Access Compliance Report

Public Rights-of-Way

Intersection ID: 10037409	Main Street: SCHOLASTIC_DR	Cross Street: N/A	Location: SE
ADA ID: 832BD22E5908	Ramp Type: PerpDiag	Initial Pass/Fail: Fail	Overall Compliance: No
		Severity Score: 25

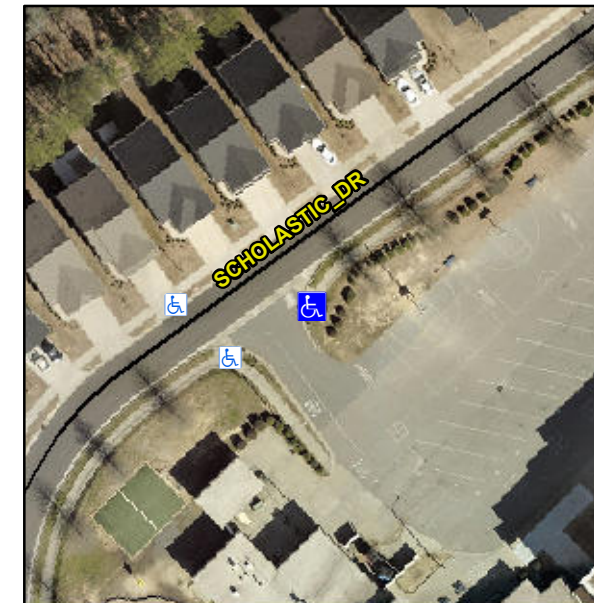
Not Found, R304.2.2, R304.5.3

Compliance	Description	Data	Compliance	Description	Data
N/A	Ramp Length (in)	63.0	No	Ramp Slope (%)	8.6
Yes	Ramp Width (in)	48.0	No	Ramp XSlope (%)	6.0
N/A	Flare Type LT	N/A	N/A	Flare Type RT	N/A
N/A	Flare Slope LT (%)	N/A	N/A	Flare Slope RT (%)	N/A
N/A	Flare Traversable LT?	N/A	N/A	Flare Traversable RT?	N/A
N/A	Landing Length (in)	N/A	N/A	DWS Provided?	N/A
N/A	Landing Width (in)	N/A	N/A	DWS Contrast?	N/A
N/A	Landing Slope (%)	N/A	N/A	DWS Length (in)	N/A
N/A	Landing X Slope (%)	N/A	N/A	DWS Full Width?	N/A
N/A	Landing Curb? (Y/N)	N/A	N/A	DWS Offset (in)	N/A
N/A	Shared Landing?	N/A			
N/A	Gutter Ponding?	N/A	N/A	Gutter Slope (%)	N/A
N/A	Gutter Lip Ht (in)	N/A	N/A	Gutter X Slope (%)	N/A
N/A	Painted X Walk1?	No	N/A	Painted X Walk2?	No
	X Walk 1 Direction	To NW		X Walk 2 Direction	To SW
N/A	X Walk 1 Width (in)	N/A	N/A	X Walk 2 Width (in)	N/A
	X Walk 1 Slope (%)	5.8		X Walk 2 Slope (%)	1.1
	X Walk 1 X Slope (%)	0.3		X Walk 2 X Slope (%)	4.3

Remove & Replace Curb Ramp With Two New Directional Ramps or Equivalent.
